TITLE:
Replace MMS with IMS

REF NO: TJ 31847.1.0	ISSUING DEPARTMENT: Technical Service	CAR MARKET: Canada	
PARTNER: 3 US 7510 Volvo Car USA		ISSUE DATE: 2016-11-03	STATUS DATE: 2016-11-08
FUNC GROUP: 3662	FUNC DESC: Burglar alarm equipment	Page 1 of 5

TJ Instruction T9388

Title	Intrusion sensor	Page:	1 (3)
Action	Modification	Operation number:	98638-2

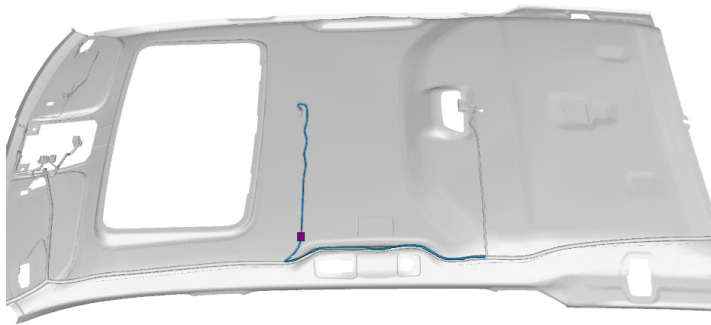
Route the cable to rear sensor and connect the adapter cable

Attached the cable with melting adhesive

Note! Use a new headlining
